Access Compliance Report

Public Rights-of-Way

(Curb Ramps)

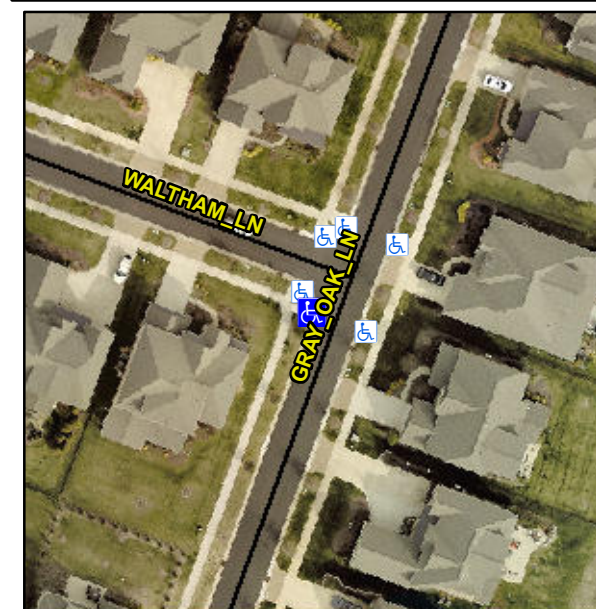
Intersection ID: 52931	Main Street: WALTHAM_LN	Cross Street: GRAY_OAK_LN	Location: W
ADA ID: 11D9F1631046	Ramp Type: Perp	Initial Pass/Fail: Fail	Overall Compliance: No
Severity Score: 10			
Codes/Mitigation Info/Possible Solution		Field Measurements/Component Compliance

R304.5.1, R304.5.3

Compliance	Description	Data	Compliance	Description	Data
N/A	Ramp Length (in)	124.0	Yes	Ramp Slope (%)	8.0
No	Ramp Width (in)	47.0	No	Ramp XSlope (%)	3.2
N/A	Flare Type LT	N/A	N/A	Flare Type RT	N/A
N/A	Flare Slope LT (%)	N/A	N/A	Flare Slope RT (%)	N/A
N/A	Flare Traversable LT?	N/A	N/A	Flare Traversable RT?	N/A
N/A	Landing Length (in)	N/A	N/A	DWS Provided?	N/A
N/A	Landing Width (in)	N/A	N/A	DWS Contrast?	N/A
N/A	Landing Slope (%)	N/A	N/A	DWS Length (in)	N/A
N/A	Landing X Slope (%)	N/A	N/A	DWS Full Width?	N/A
N/A	Landing Curb? (Y/N)	N/A	N/A	DWS Offset (in)	N/A
N/A	Shared Landing?	N/A			
N/A	Gutter Ponding?	N/A	N/A	Gutter Slope (%)	N/A
N/A	Gutter Lip Ht (in)	N/A	N/A	Gutter X Slope (%)	N/A
N/A	Painted X Walk1?	No	N/A	Painted X Walk2?	N/A
	X Walk 1 Direction	To SE		X Walk 2 Direction	N/A
N/A	X Walk 1 Width (in)	N/A	N/A	X Walk 2 Width (in)	N/A
	X Walk 1 Slope (%)	4.5		X Walk 2 Slope (%)	N/A
	X Walk 1 X Slope (%)	2.3		X Walk 2 X Slope (%)	N/A

Remove & Replace Entire Ramp.
